TO: Commission Members
FROM: Marcia Spencer Famous, Senior Planner
DATE: July 7, 2010
SUBJECT: Development Permit DP 4860; deliberation notebook

On December 23, 2009, the application for Development Permit DP 4680 submitted by TransCanada Maine Wind Development, Inc. for the Kibby Expansion Project (KEP) was accepted for processing. State agencies, Intervening Parties, and the public submitted comments and testimony on the proposal, and on May 11 and 12, 2010, a public hearing was held, with the record closing on June 1st. Closing briefs were submitted by the Parties on June 8th, and summaries will be presented by each Party today.

APPENDIX 2
 VIEWSHED ANALYSIS MAP DETAIL: CHAIN OF PONDS

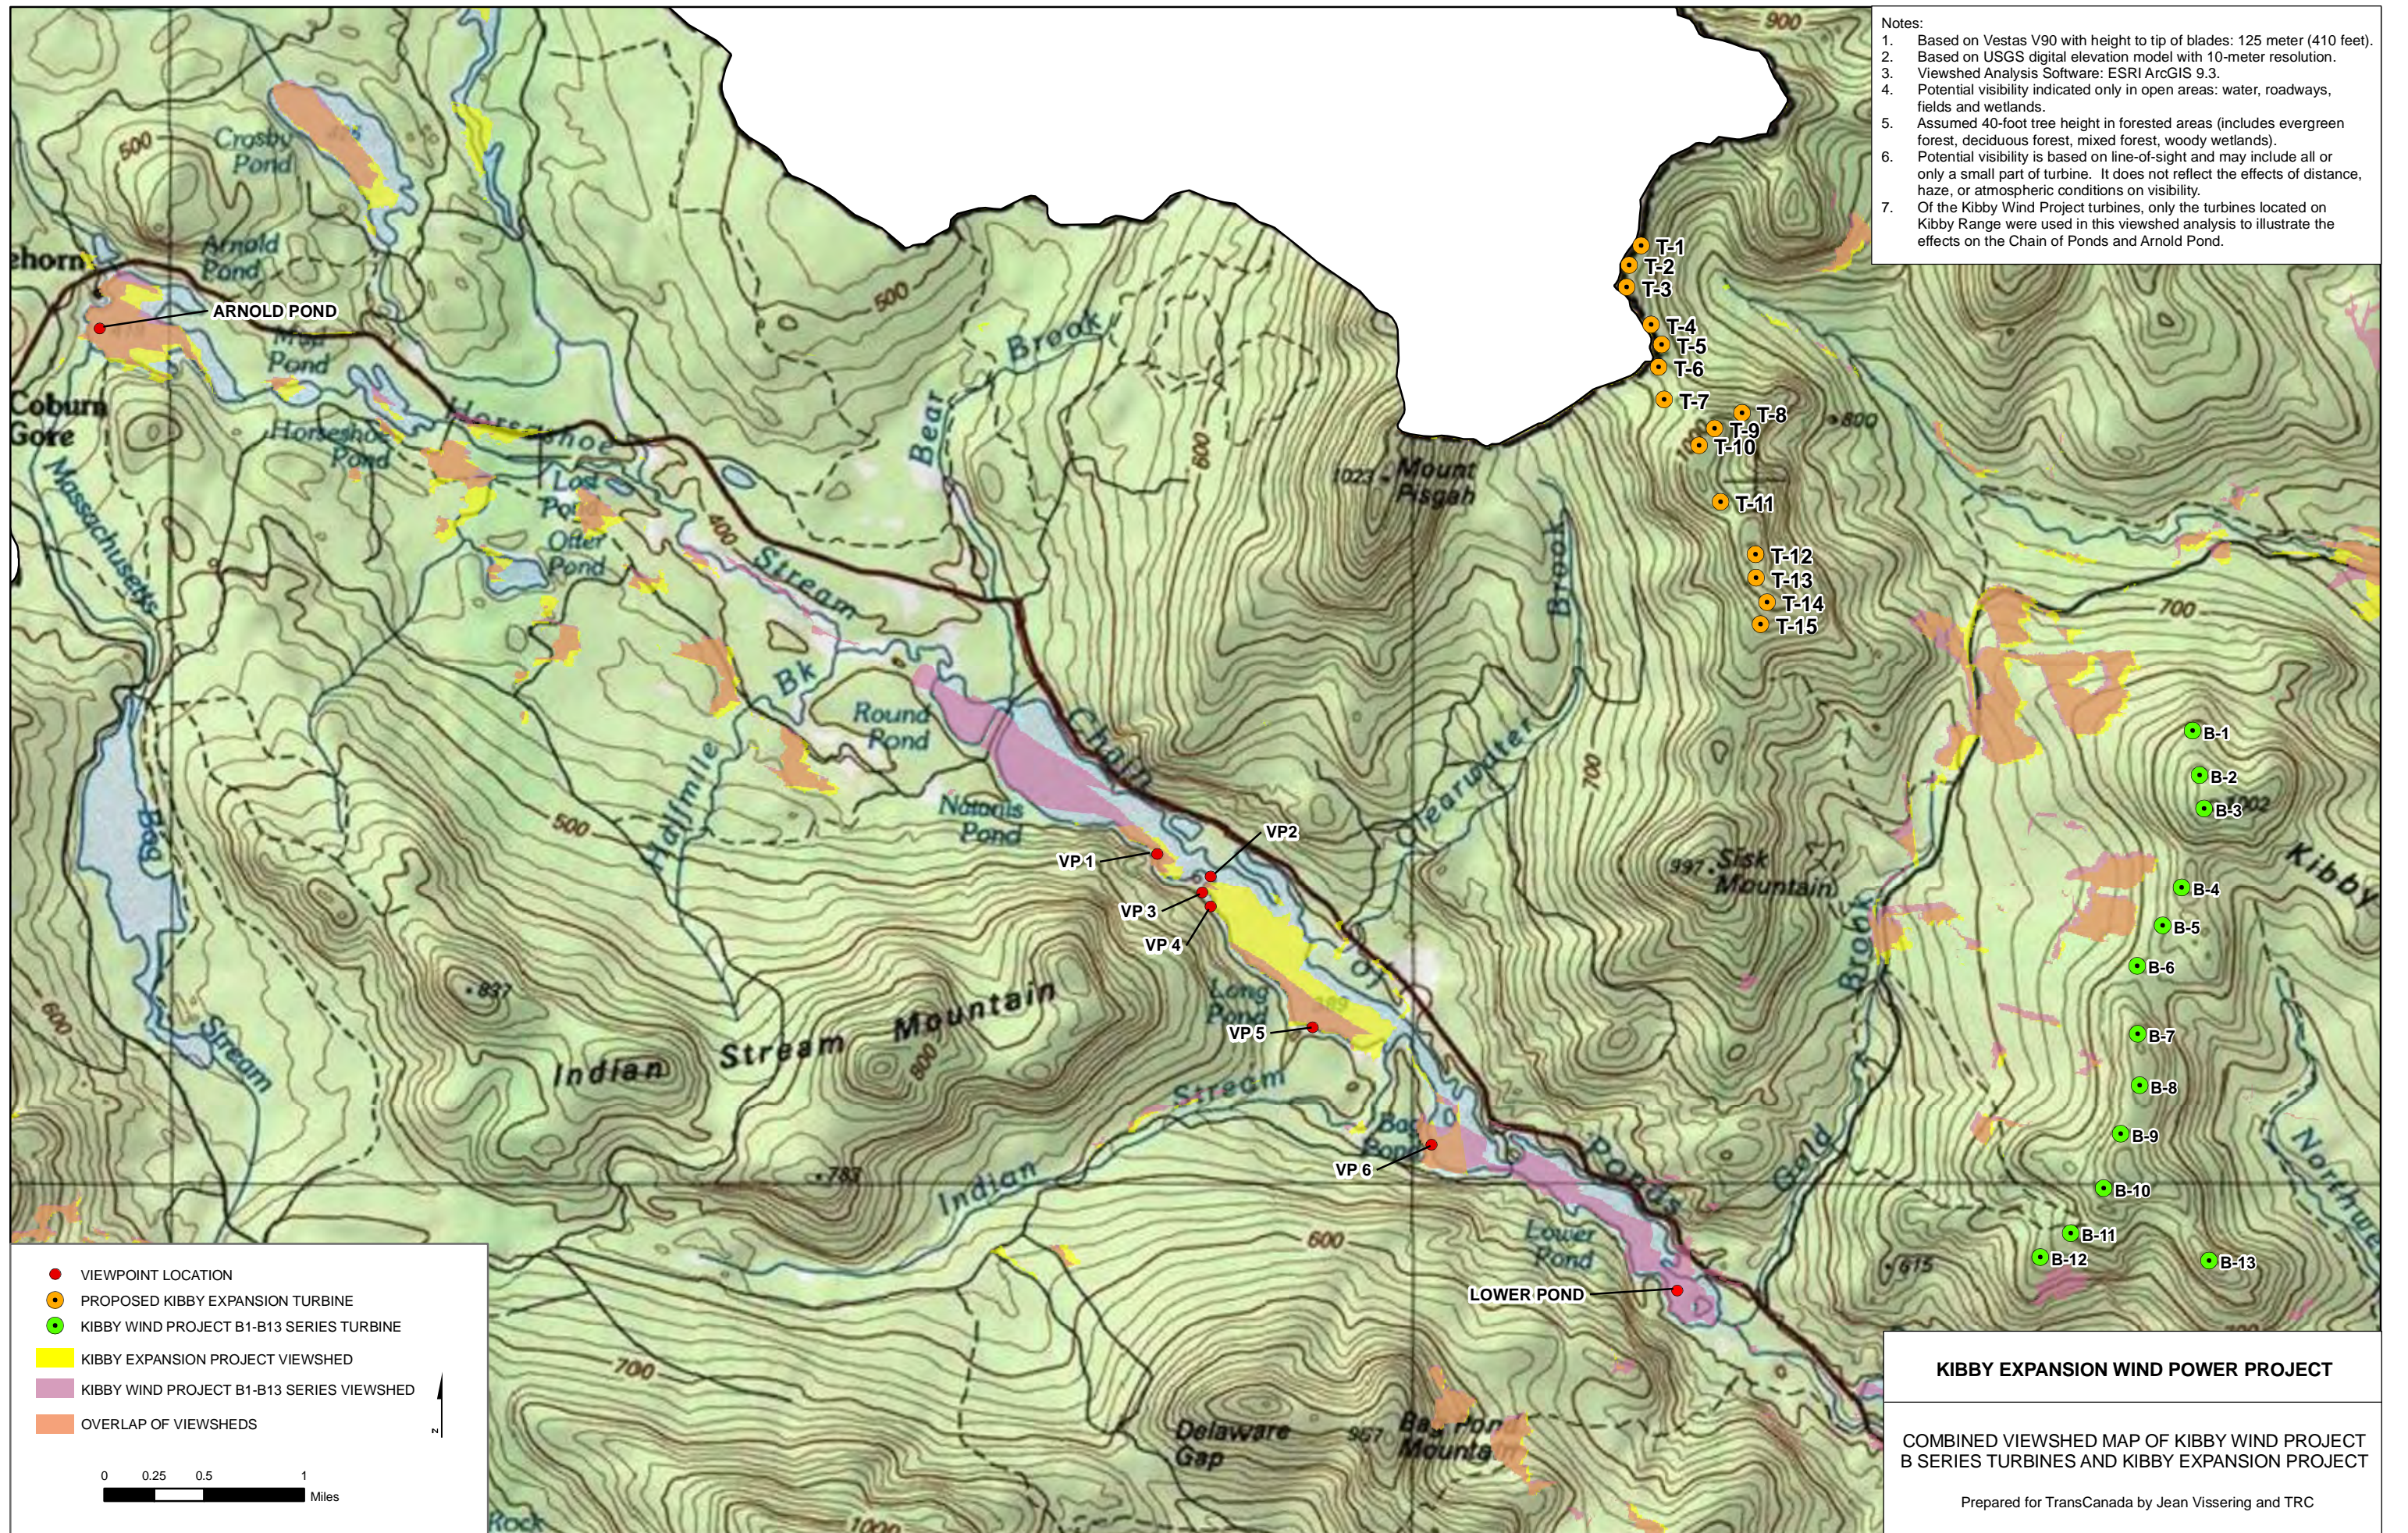
- (3) Mr. Palmer’s independent fieldwork and additional analyses determined that the primary visual impacts would be to Chain of Ponds and Kibby Stream (which has the potential for large cumulative impacts). The applicant’s visualizations were generally accurate, although the turbines in several of the simulations had lower contrast than would be indicated under the principle of representing the “worst case” view. However, the simulation viewpoints on Chain of Ponds provide a good representation of the “worst case” conditions. Finally, it is clear that there may be significant visual impacts to Kibby Stream that were not fully investigated.

F. *Scenic impact to Chain of Ponds.* In response to BPL's assertion the visual assessment is not specific enough, the applicant noted the visual assessment states the project would be visible from approximately 31% of Chain of Ponds, and includes significant written text, photographs and visual simulations detailing how the project would impact the surrounding scenic resources.

In response to BPL comments, the applicant conducted a more detailed analysis of Arnold Pond, and noted an error in the estimate of project visibility. The application stated that only the southern turbines would be visible. However, the additional analysis indicated that portions of up to 9 of the northernmost turbines may be visible to the north of Mt. Pisgah at a distance of 7 to 8 miles, while views of the southerly turbines will likely be blocked by Mt. Pisgah (the dominant landform visible from the pond, with any turbines visible well below the height of land). A simulation illustrating the views from Arnold Pond was prepared and submitted by the applicant with its pre-filed testimony.

Figure 7. Arnold Trail Map and Guide (Source: Center for Community GIS in Farmington, Maine using funds donated by TransCanada)

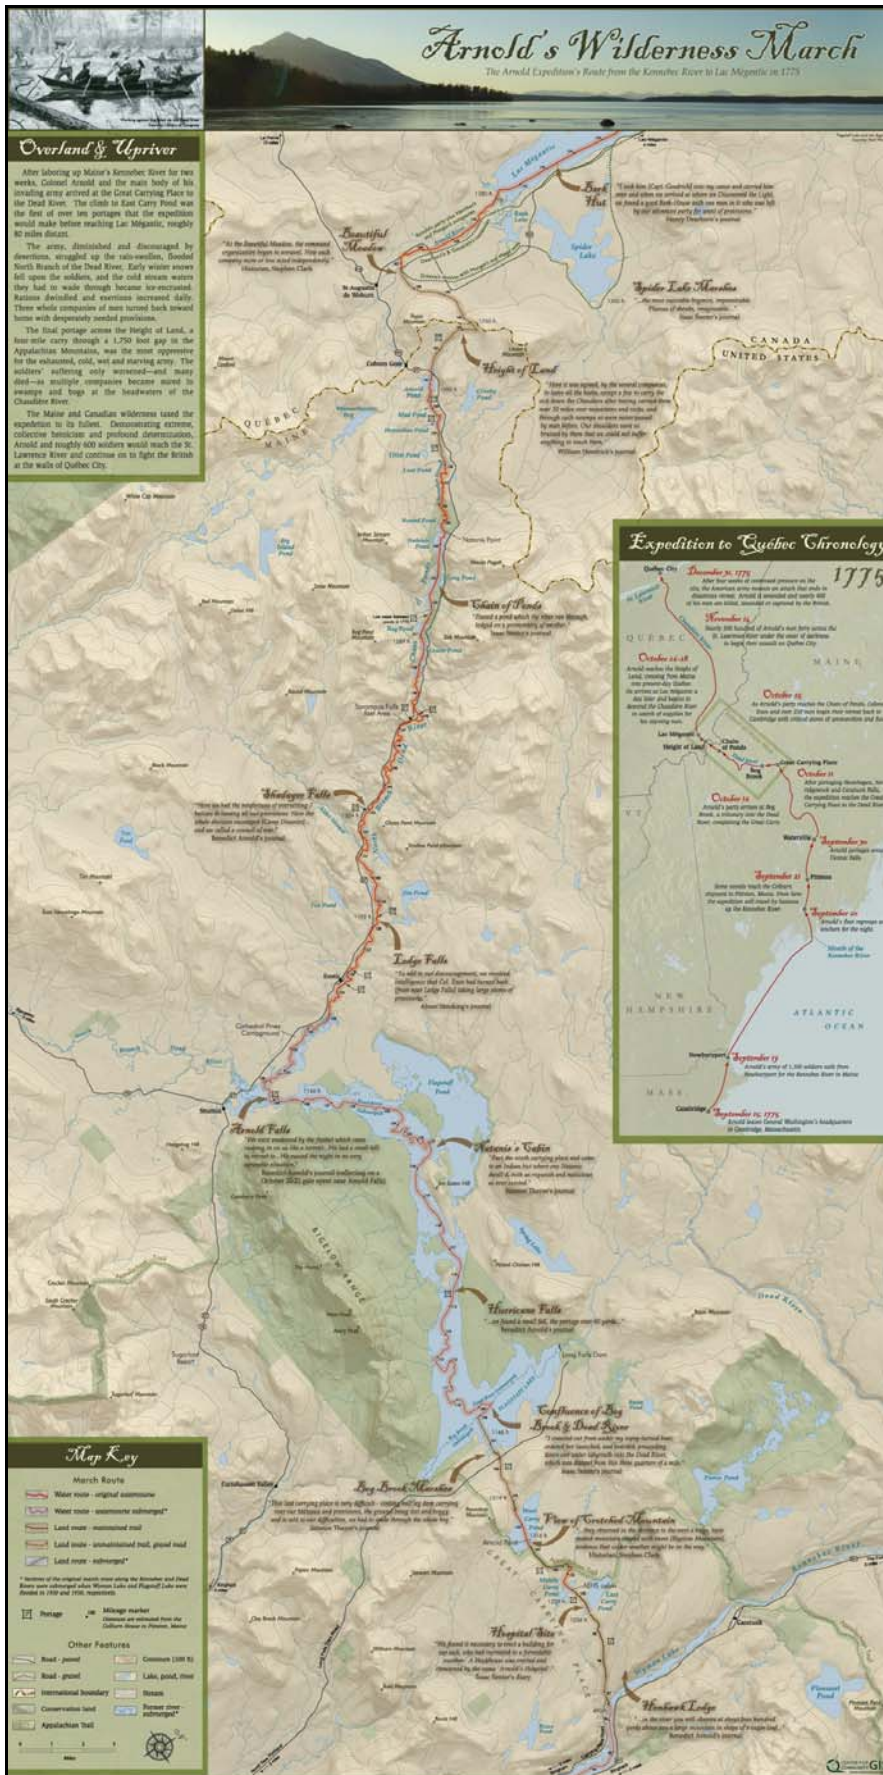
- G. *Arnold Trail.* BPL asserted that the historic significance of the Trail, or important points along the Trail were not adequately addressed. BPL has an interest in the Trail due to ownership of the Coburne House, on-staff historic expertise, collaborations with Trail and Byway groups, and ownership of the Public Reserve Lands at Chain of Ponds. BPL noted that its management plan for this area does not address views because it does not own the views. Nevertheless, BPL asserted that the Trail and the Chain of Ponds are synonymous, and should have been addressed jointly. Because of the significance of the Trail, on-site mitigation should be required.

- (2) The purpose of a visual impact assessment is not to provide a history of the Trail, but to examine the extent of compromise to its historical significance and the experience of users interested in the historical context by the proposed KEP. Whether the surrounding landscape is documented as a critical part of the historic context was considered. Route 27 and its scenic turnout, parking areas, and facilities; the commercial campground; and private residences along Chain of Ponds did not exist at the time Arnold made his journey and have altered the "vast wilderness" the Arnold company encountered on its northward march. The historic significance of the Trail and the environs immediately surrounding it could continue to be enjoyed in the same manner it is today with the distant and limited views of wind turbines several miles away, receding well behind the foreground features.

- (3) The historical documentation of the Trail does not identify the northern Sisk ridgeline as a critical part of the Arnold Trail, and does not provide specific information about Chain of Ponds or Arnold Pond. There is no evidence to suggest that wind turbines located 3 to 8 miles away and behind the more prominent foreground peaks would compromise the historical experience.
